# **TOWN OF PLAINFIELD PLAN COMMISSION REPORT**

**CASE NO.:** DP-18-027

**PETITIONER:** Distribution Realty Group - DRG

**REQUESTED ACTION:** Development Plan/Arch. & Site Design Approval

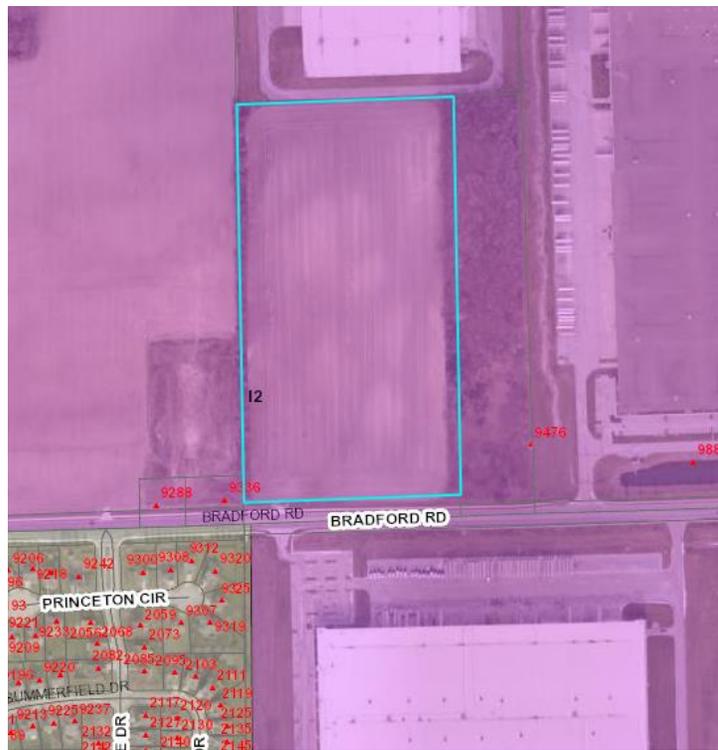
Staff has raised concerns about queuing, largely driven by two potential drives proposed as future access points for existing & adjacent facilities. The included image shows the proposed locations of the drives, both for this proposed site as well as two locations flanking the property. Admittedly, the proximity of the drives is not ideal, but attempts to coordinate shared access drives have not been supported by both parties.

The developer completed a traffic study, including a follow-up memo to address the specific concerns expressed by staff. Both are available for review. Based upon the technical analysis, the engineer has concluded anticipated queuing distances and level of service are not expected to adversely impact adjacent access drives.
